BUCKHEAD ADDITION

WICHITA, SEDGWICK COUNTY, KANSAS

Re: 94-79 BUCKHEAD ADDITION (Final Plat)

CASE NUMBER: S/D 94-79 BUCKHEAD ADDITION

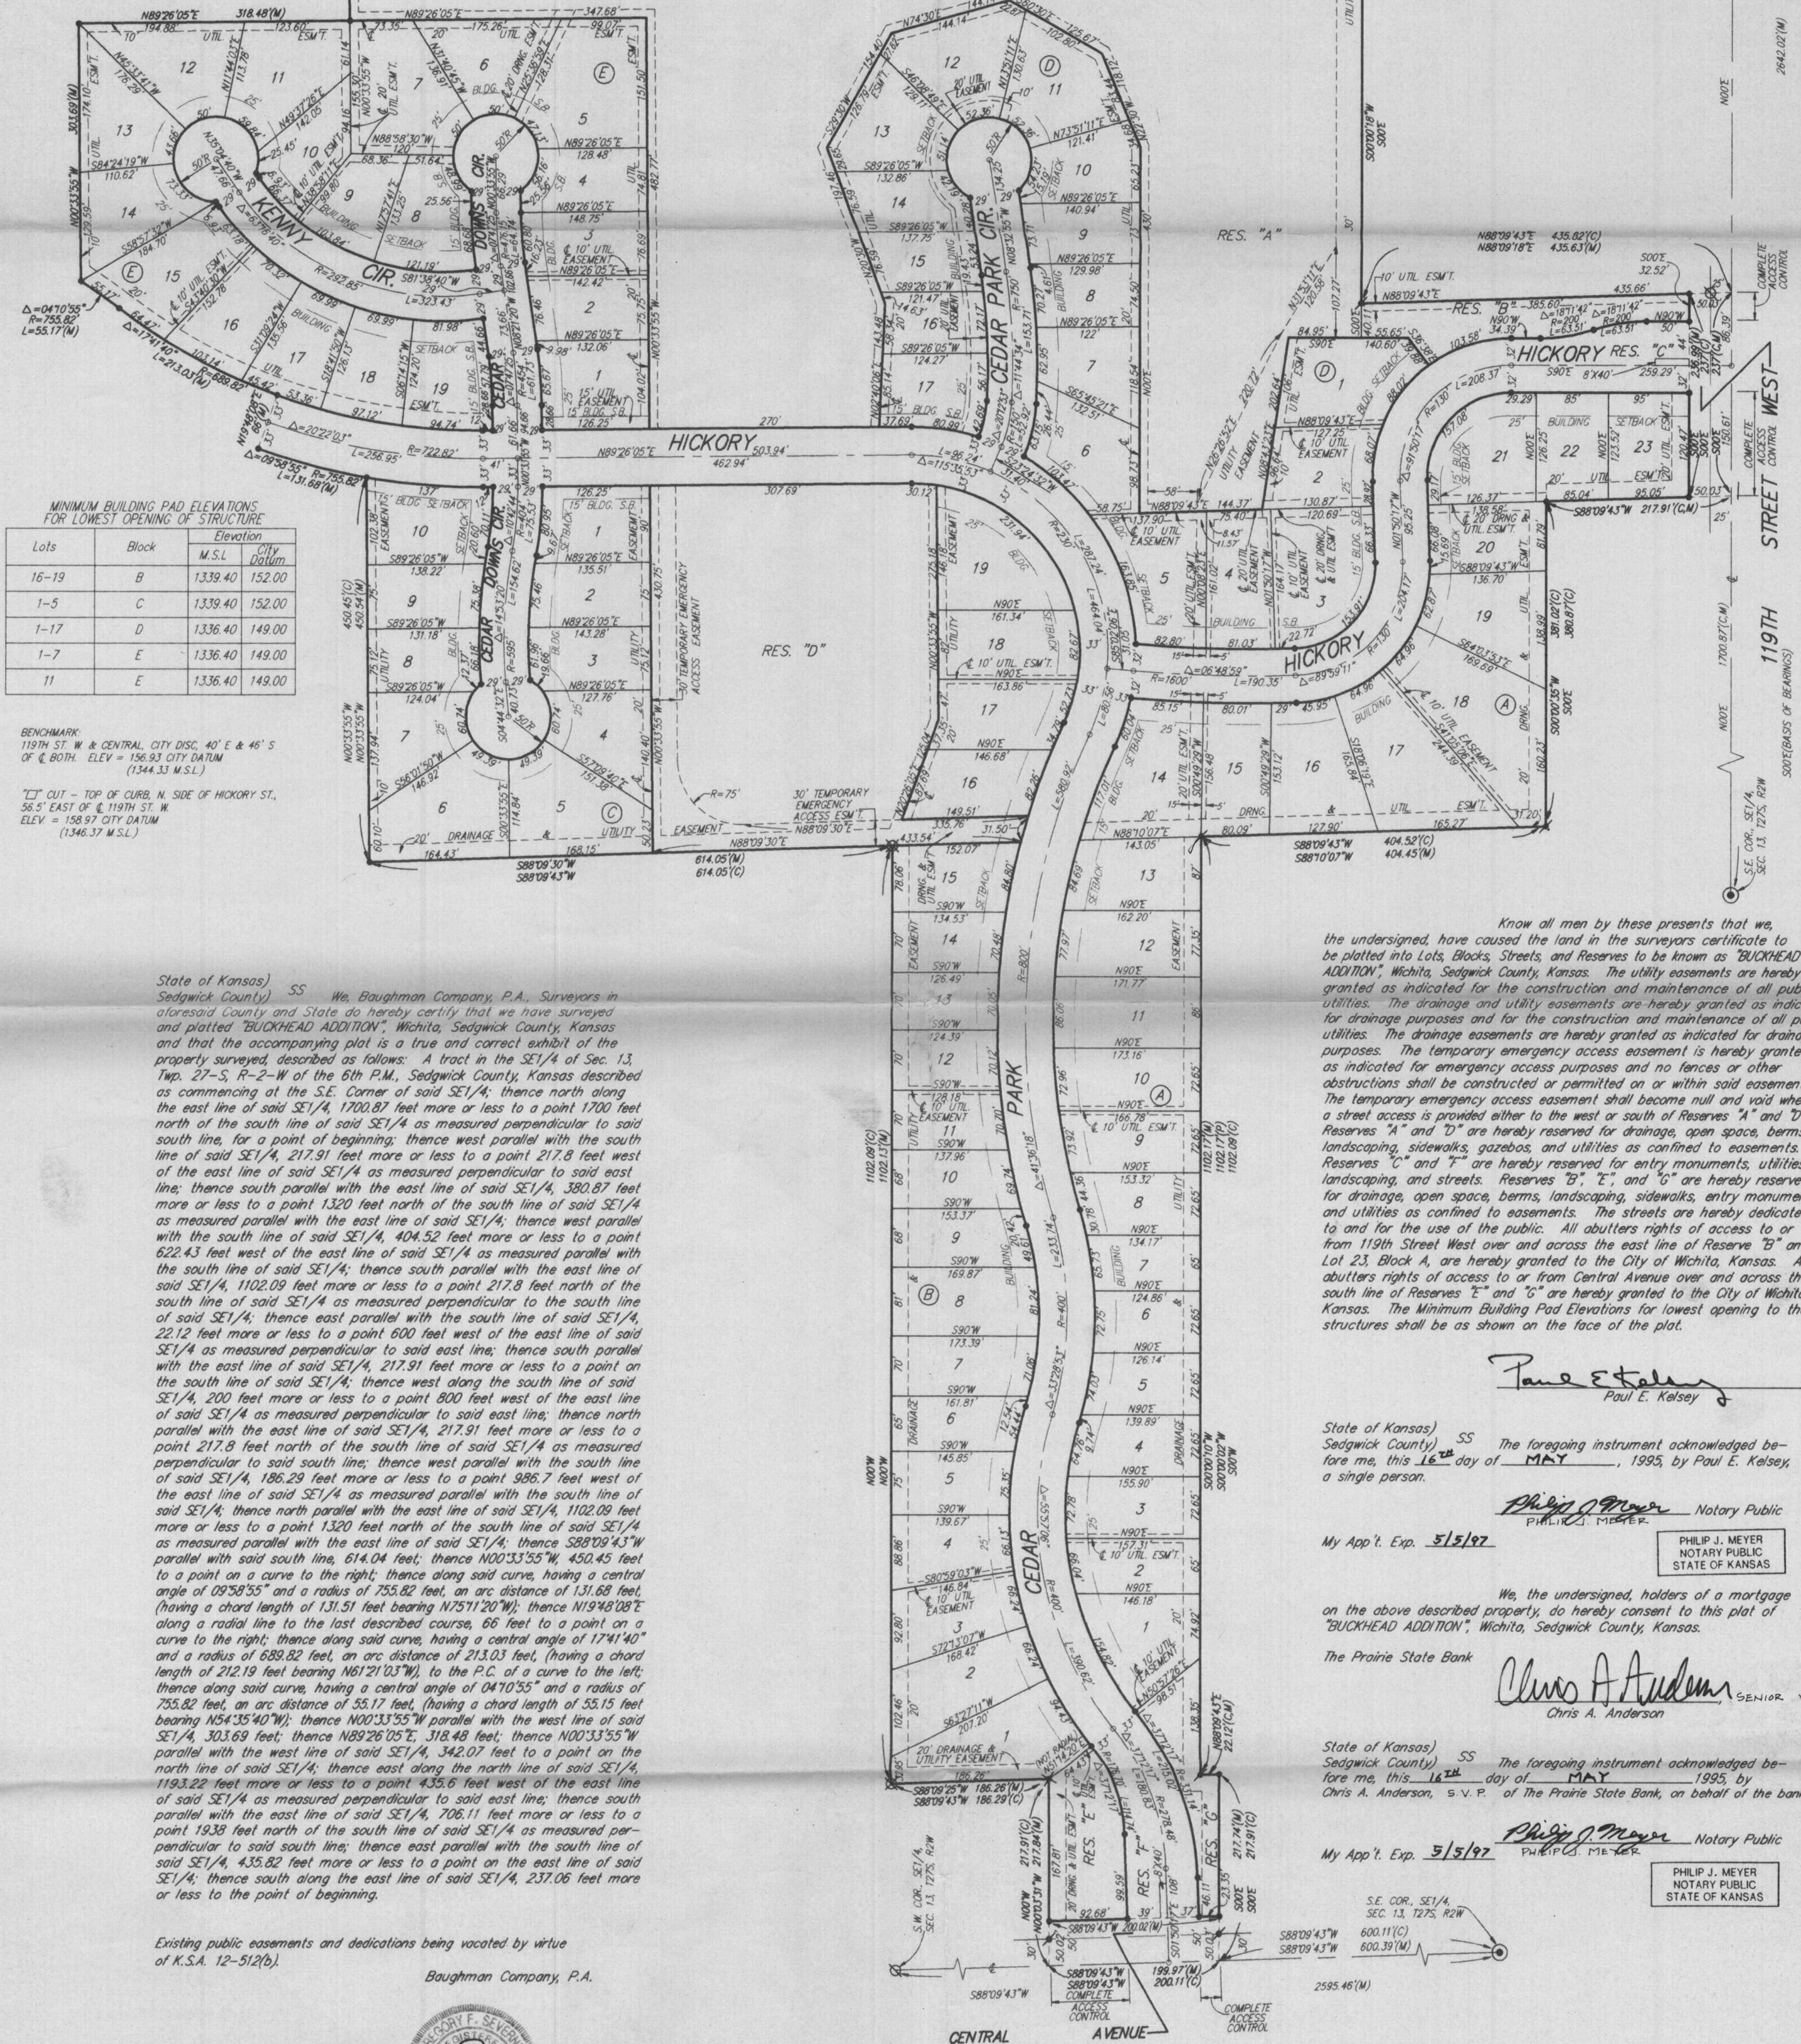
- ☒ D. The applicant shall guarantee the paving of the proposed interior streets. As indicated on the plat, Cedar Park/Hickory will require paving to the collector street status. In regard to sidewalks, the paving guarantees shall include a sidewalk on both sides of Cedar Park/Hickory (a collector), one side of Hickory as it extends out to 119th Street West and one side of the looped street Firefly-Birch-Bay Country.

cul-de-sac street. The two cul-de-sac streets noted as Cedar Down Ct. should for instance be named Circles. Also, this street should be called Cedar Downs, which agrees with the existing name in this area. In regard to Kenny, this street should be a circle.

L. In order to make the Reserves more accessible to the residents in the addition, it is recommended that additional access, such as an extension of the Reserves be provided in such locations as in the area of Lots 5 and 6 from Hickory to Reserve A.

M. For lots adjacent to the Lakes, the final plat tracing shall reference the required minimum building pad elevations in Mean Sea Level as well as City Datum. The platting of the minimum building pad elevation shall be noted on the face of the plat as well as in the plat's text.

N. Since this property is establishing minimum building pad elevations, the face of the plat shall reference the location and elevation of permanent on-site and off-site benchmarks. Section 5-402(N).

- T. On the final plat tracing, the platlor's text shall be amended to note that streets are being dedicated to and for the use of the public.
- U. For Lots 1 & 2, Block D a 25-foot building setback to Hickory shall be platted.

- Z. The final plat shall indicate the utility easements requested by K.G.& E. Bell which is indicated on the enclosed "marked" copy of the plat.
